AS BUILT PLANS
 Contractor: McCullough Excavation
 Inspector: Larry Powell, Baughman co.
 As Built by: KEK, 2/7/22

WATER DISTRIBUTION SYSTEM to serve **RED ROBIN**

7355 W. TAFT ST.
 CITY OF WICHITA, KANSAS

LINE 1

When fire service and domestic water line installed in same trench, trench shall be compacted per detail, this sheet.

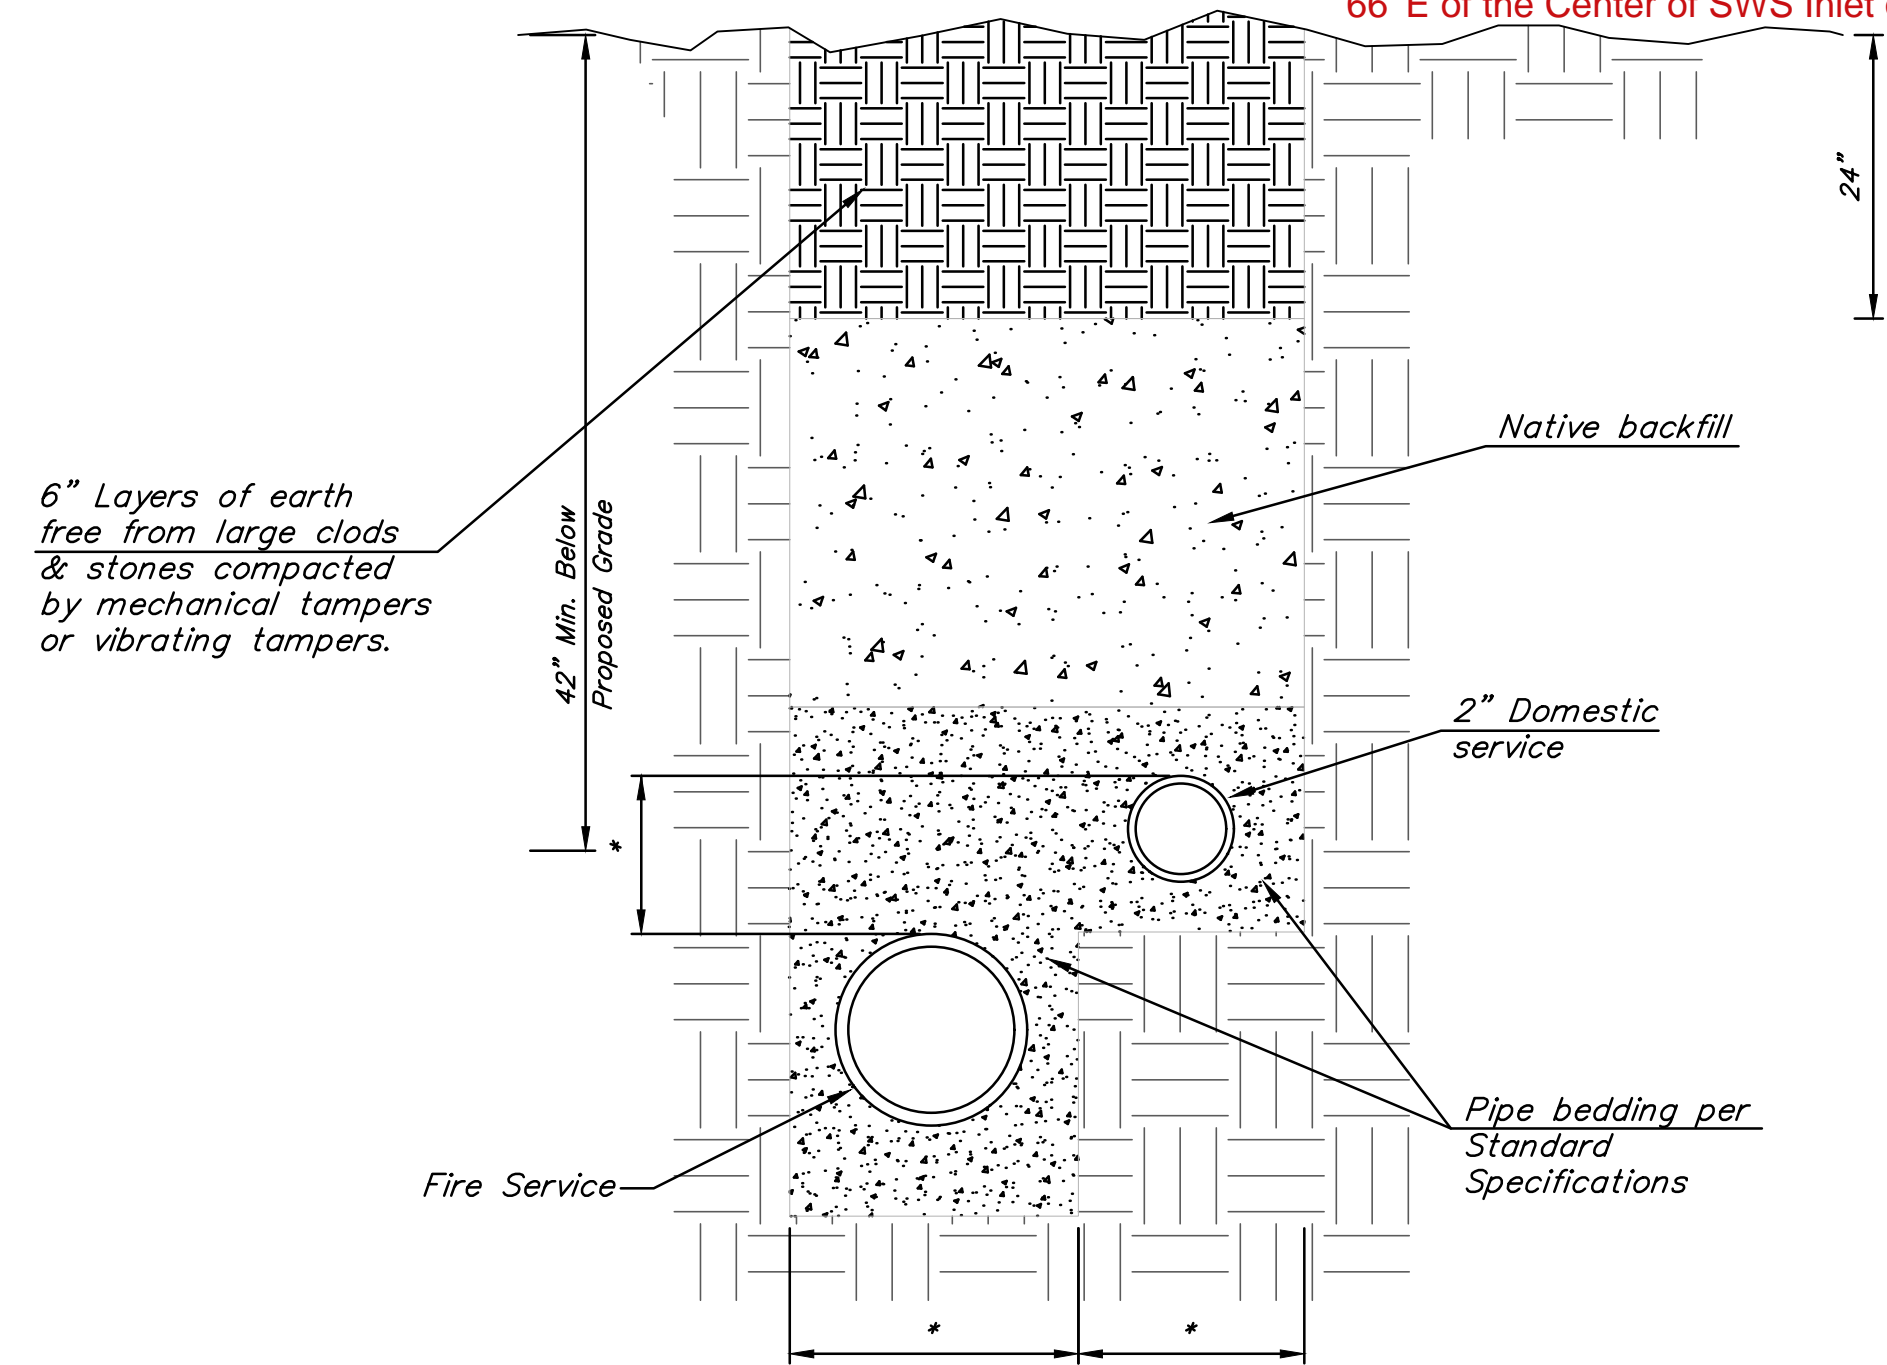
Tee is 37' S of the CL of University St.
 66' E of the Center of SWS Inlet on S Side of University St.
 Valve is 37' S of the CL of University St.
 68' E of the Center of SWS Inlet on S Side of University St.
 Fire Hydrant is 37' S of the CL of University St.
 71' E of the Center of SWS Inlet on S Side of University St.

Tee is 32' S of the CL of University St.
 66' E of the Center of SWS Inlet on S Side of University St.
 Valve is 34' S of the CL of University St.
 66' E of the Center of SWS Inlet on S Side of University St.
